Addendum 2

ADDENDUM: NO. 2

PROJECT:	2024-130-P02024 Pavement Rehabilitation and Playground Renovation		
PROPERTY:	Queen Mary Elementary school		
ADDRESS:	1292 Cannon Street East, Hamilton, ON		
MATTER NO.:	100241787	ISSUED DATE:	April 29, 2024

SHEET TITLE:
CHAIN LINK FENCE LAYOUT DETAILS

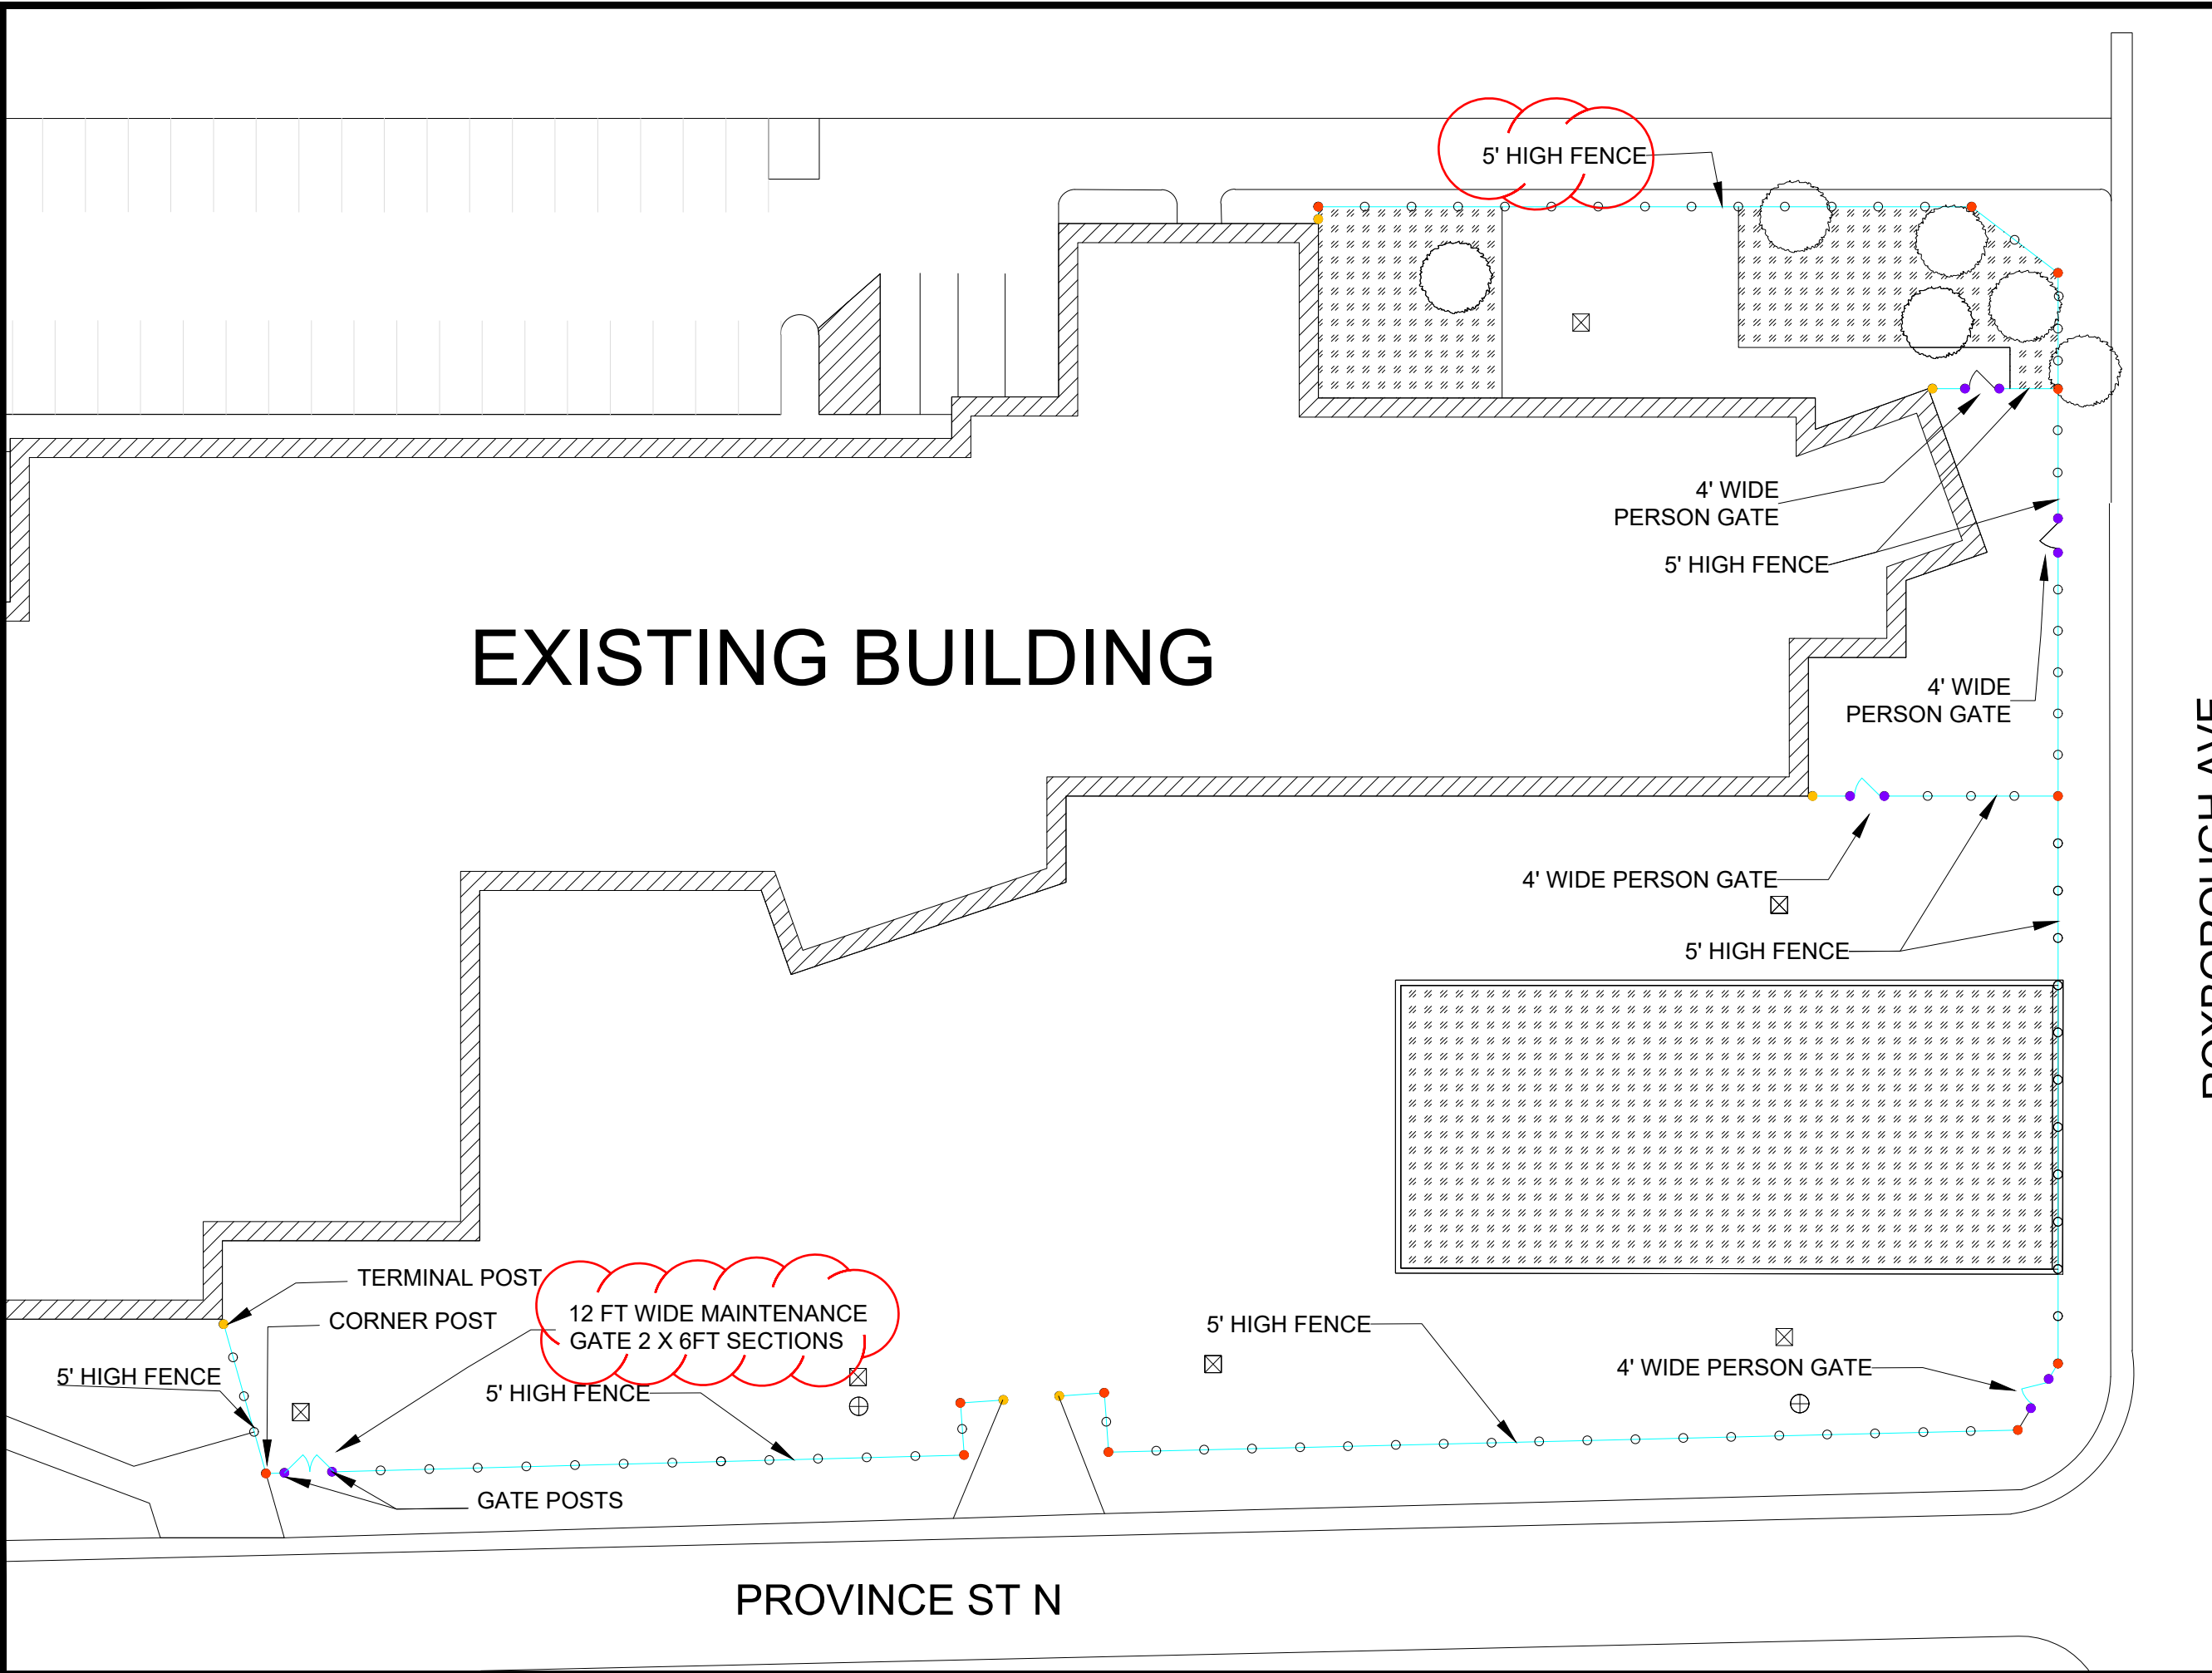
Q2. Please confirm the height of the fencing around the kindergarten area as the note on drawing D3 states new 6' tall fence it also calls out 5' fence

A2. All new chain link fence lines be 5 ft from the finished surface level. Refer to updated drawing #D3.

SHEET TITLE:
CONCRETE CURB LAYOUT AND DETAILS

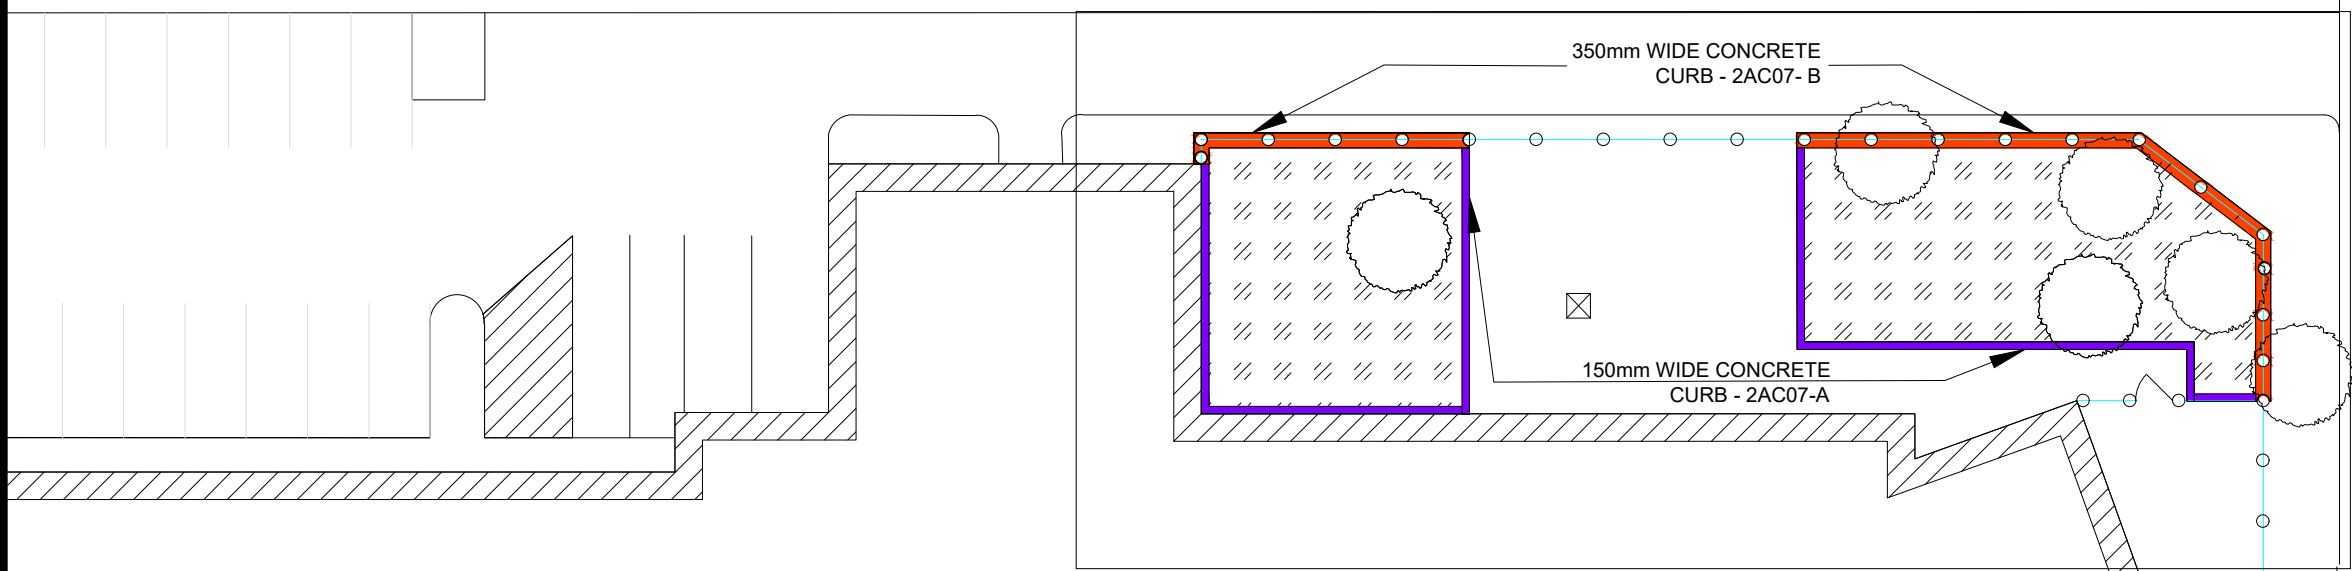
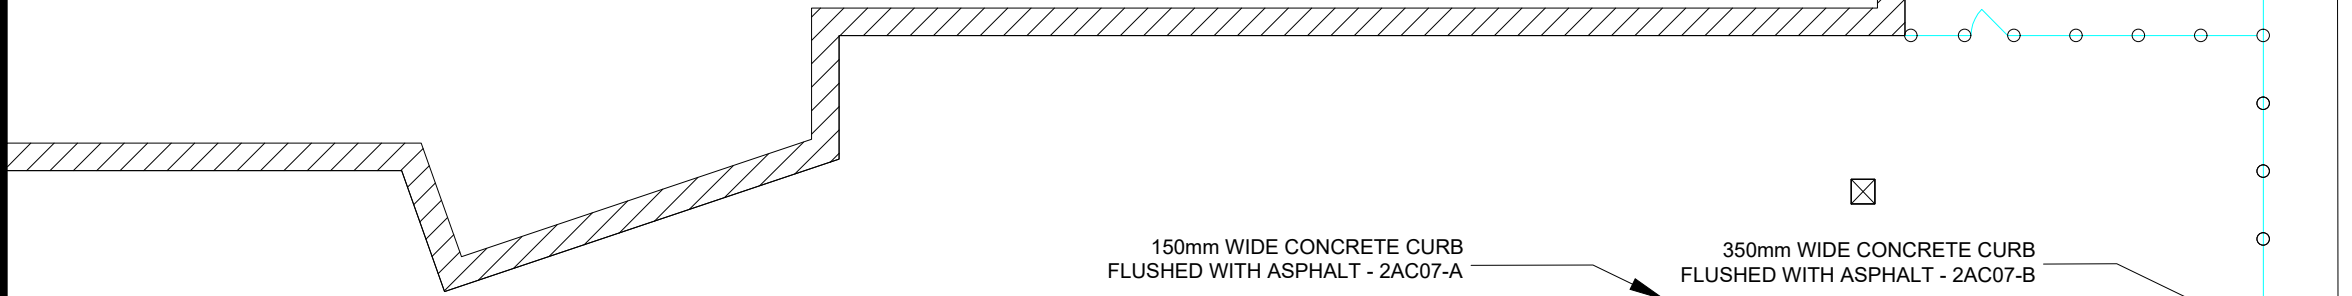
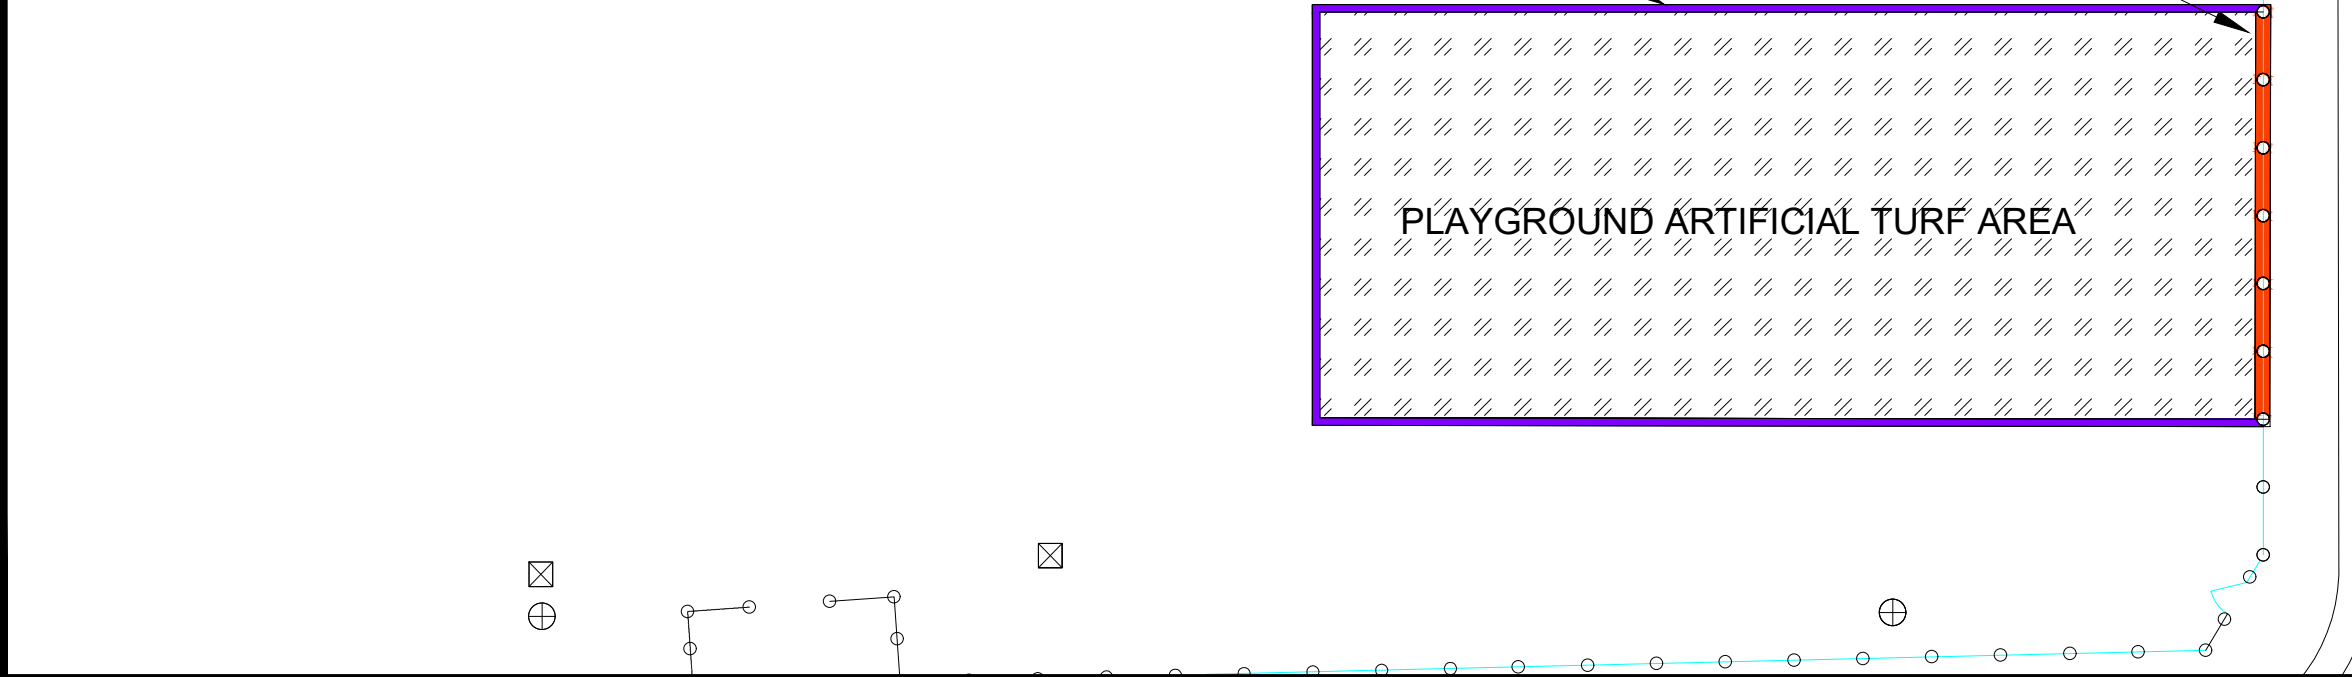
Q4. Please confirm the width of the section of curb in the kindergarten areas. The drawings call out 350mm wide curb, but in the specs under the turf scope of work it mentions 300mm wide curb

A4. The drawings and specifications have been updated to reflect a 350mm wide curb.
